# construction bid document addendum 02

project: Southern Maine Community College - Horticulture Greenhouse  
Midcoast Campus, Brunswick, Maine BGS # 3674

date: 15 November 2024

## HORTICULTURE GREENHOUSE

A20

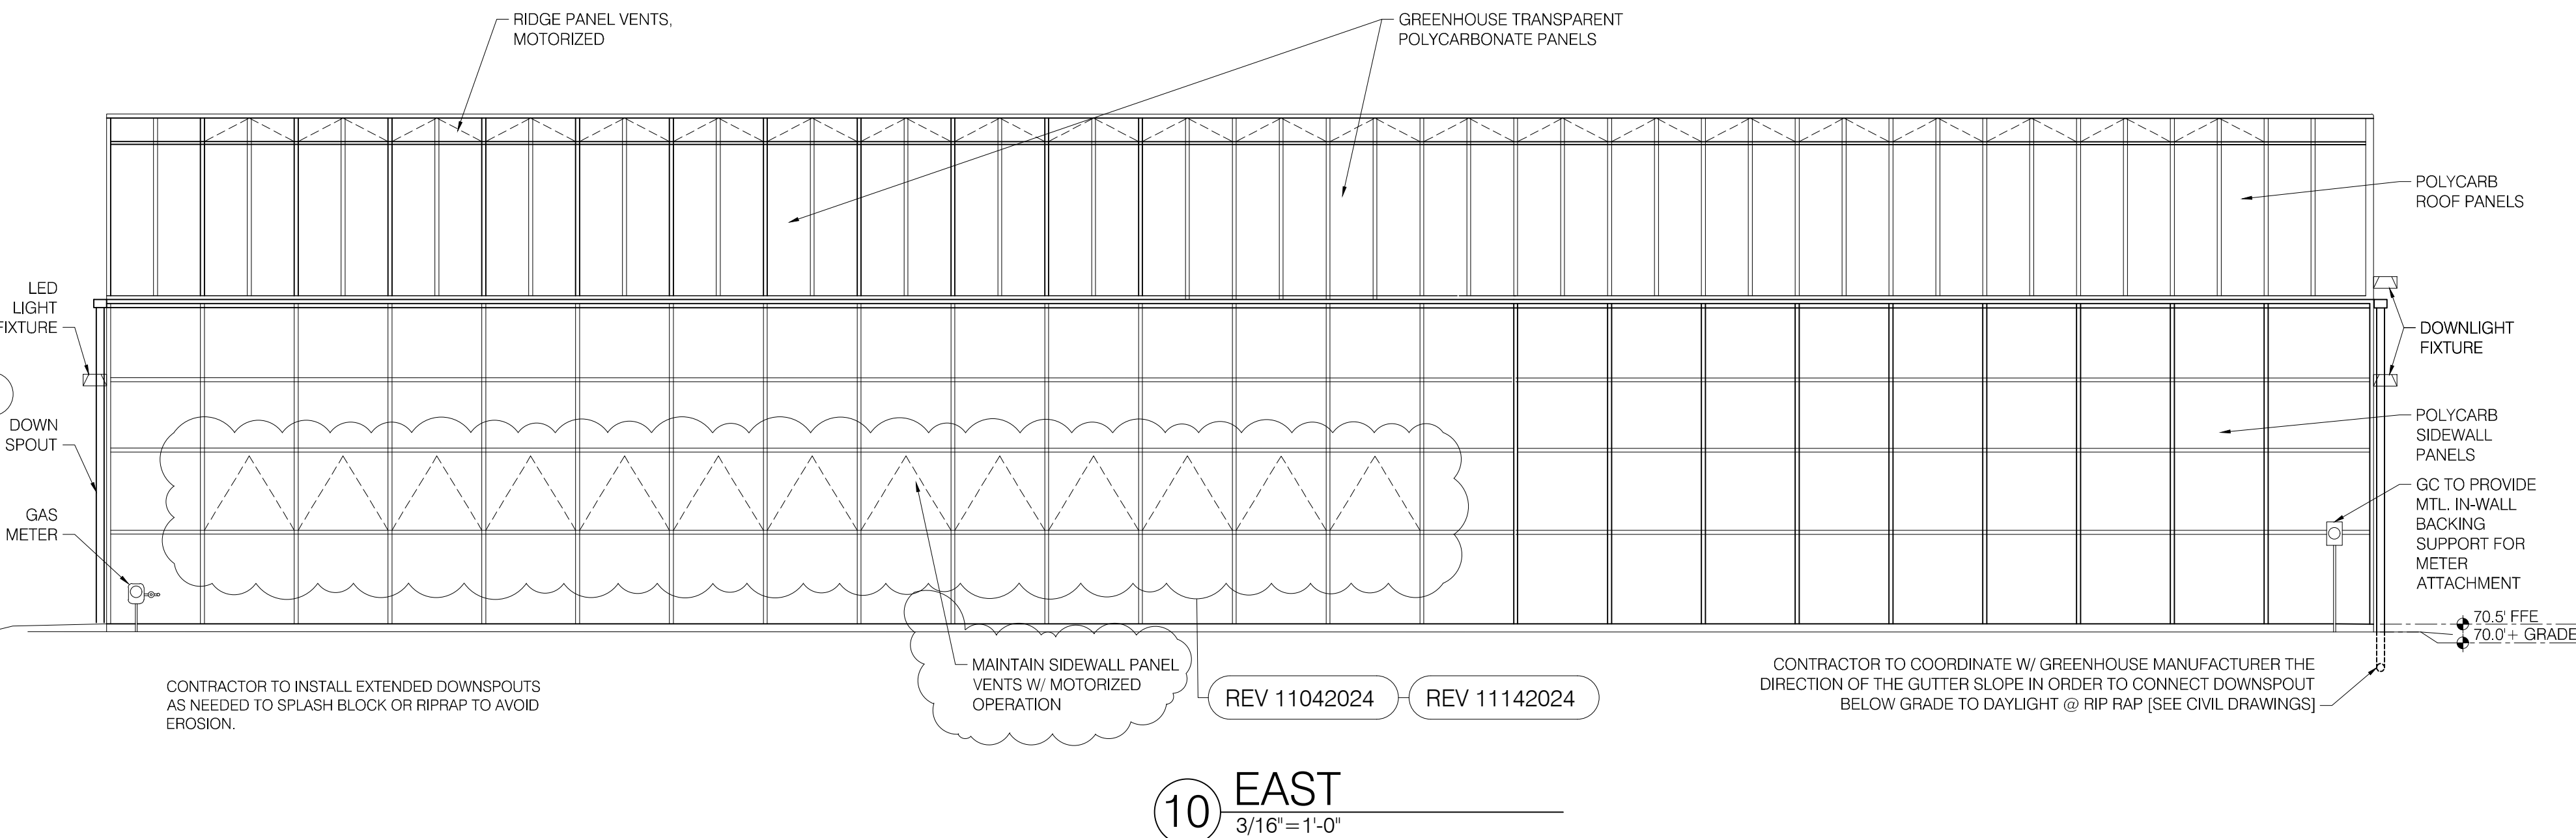
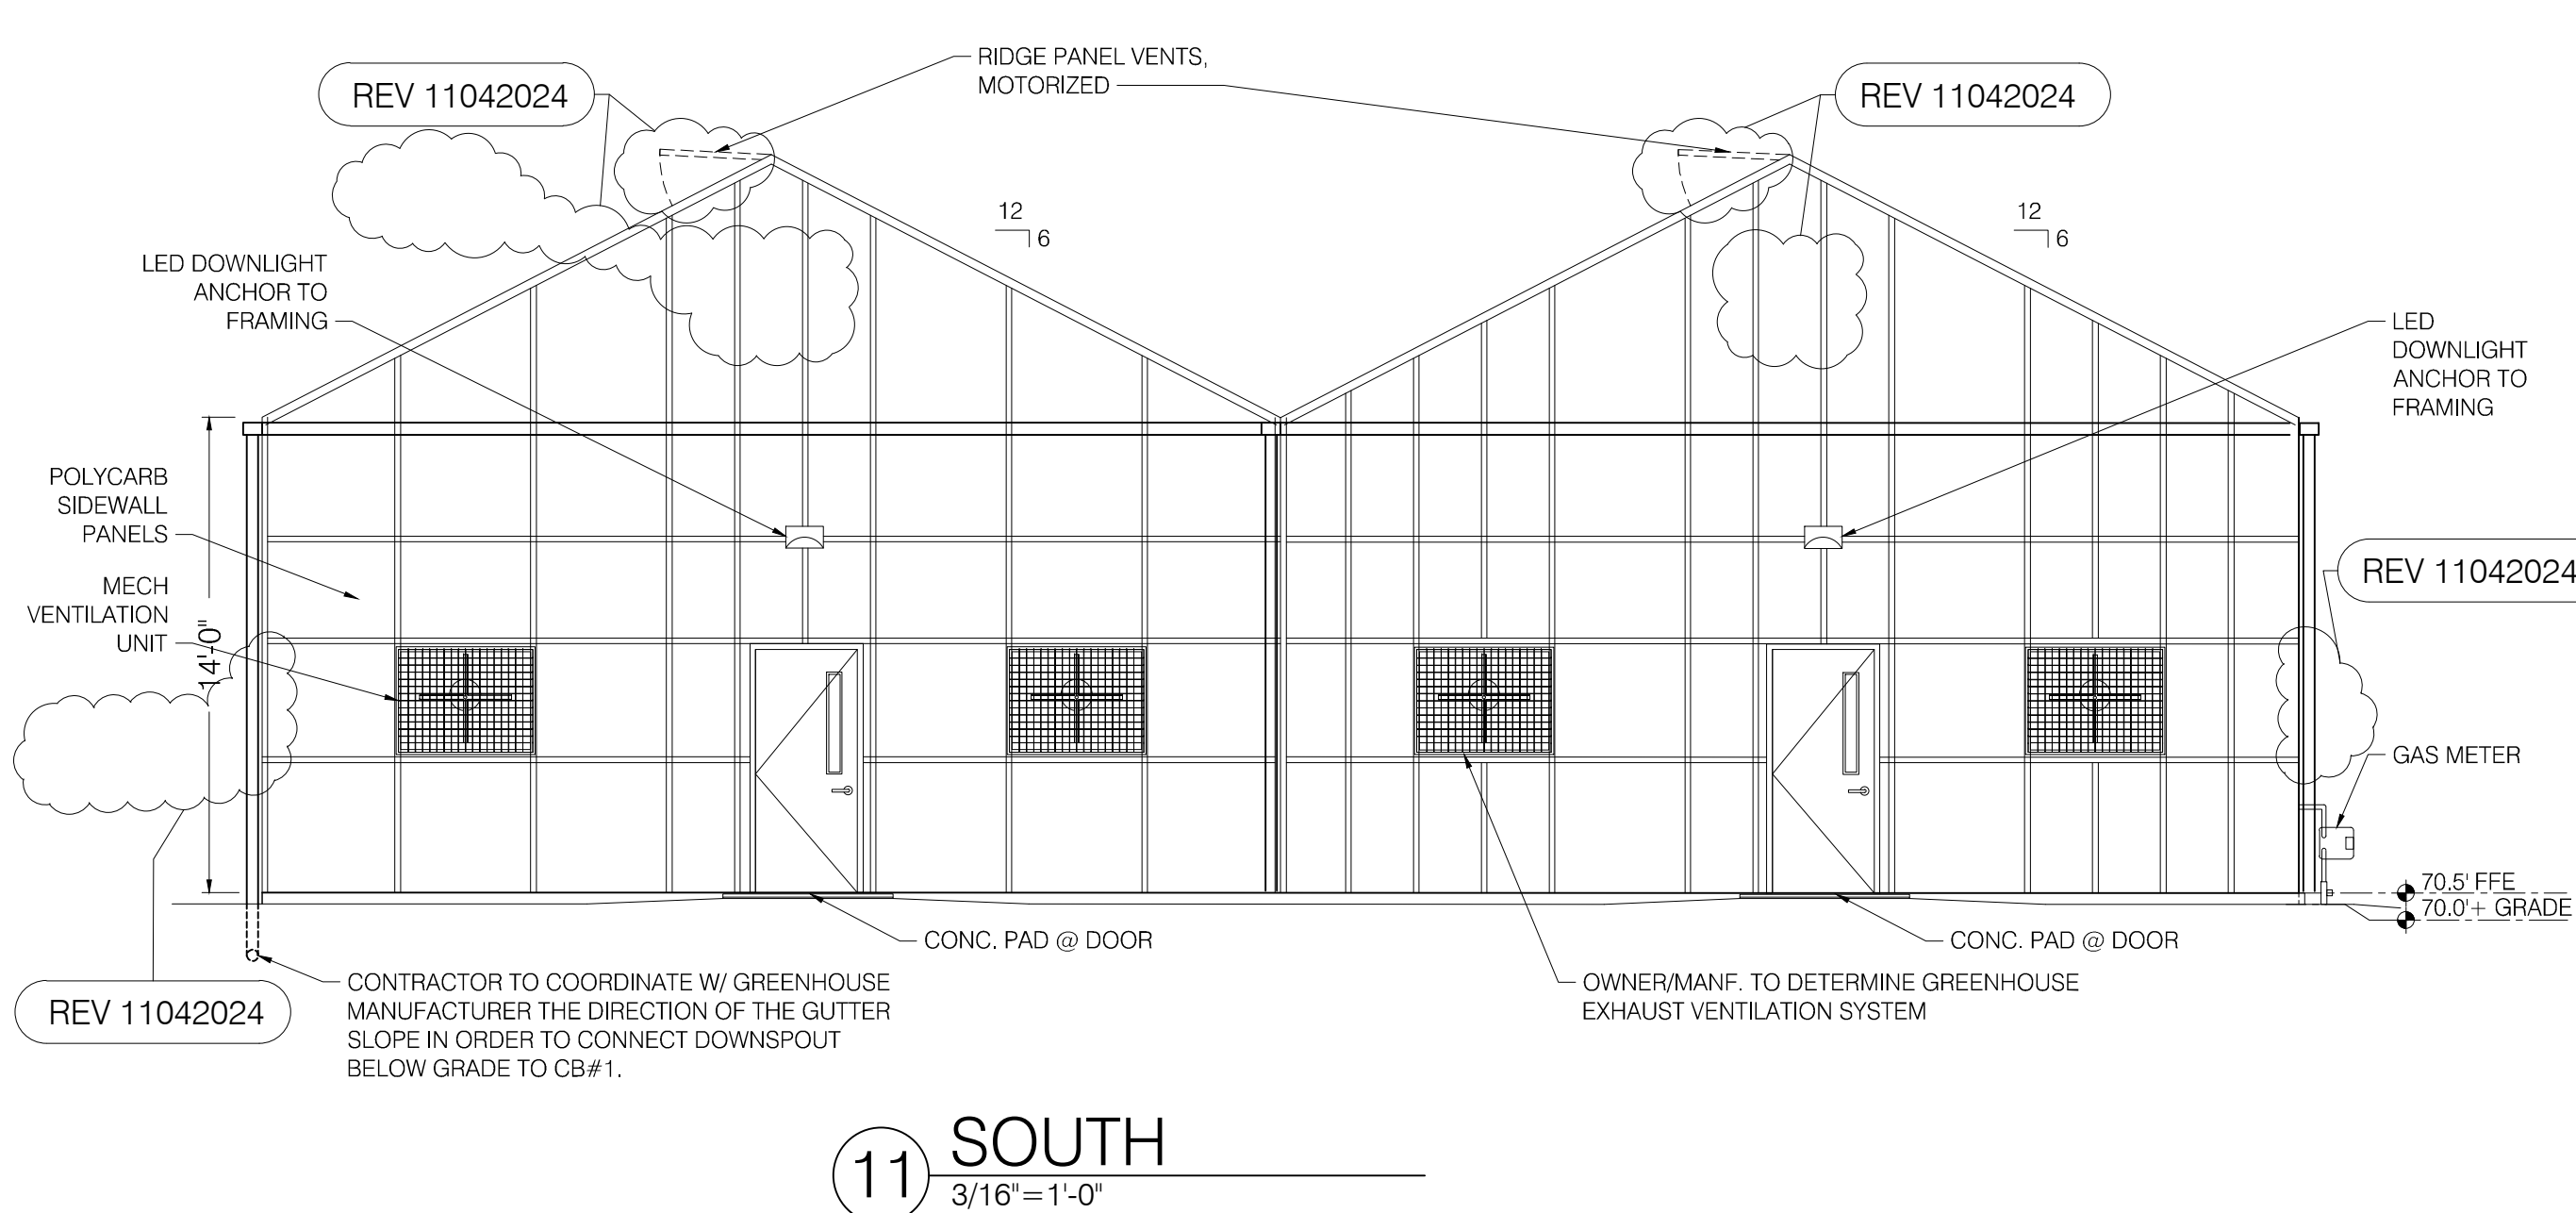
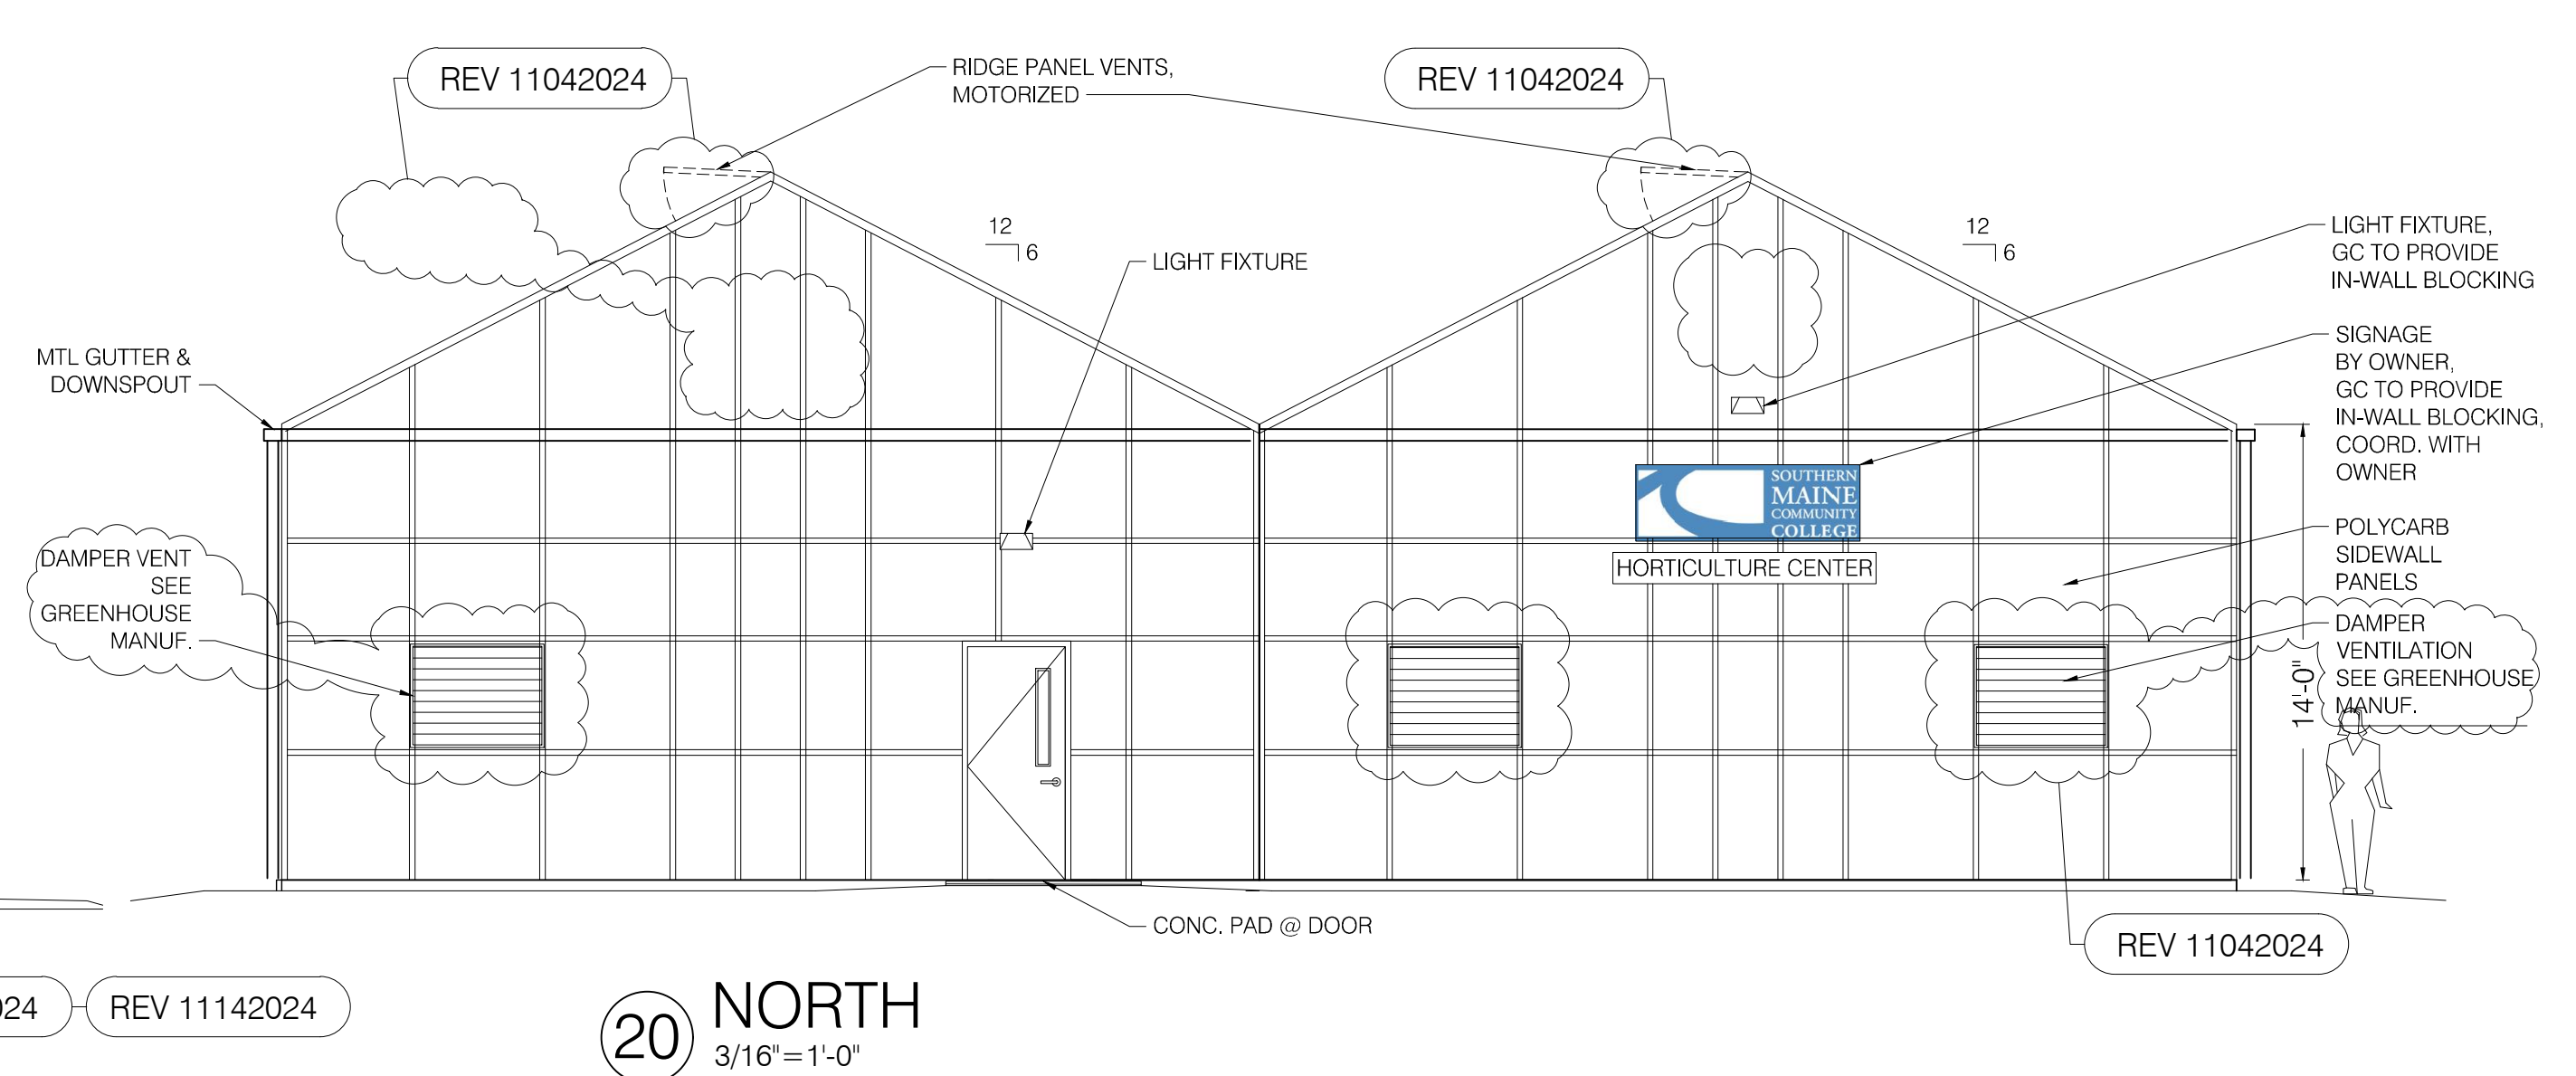
A20 EXTERIOR ELEVATIONS: Motorized wall panel ventilation to be retained with reduction of east wall side vents as shown.
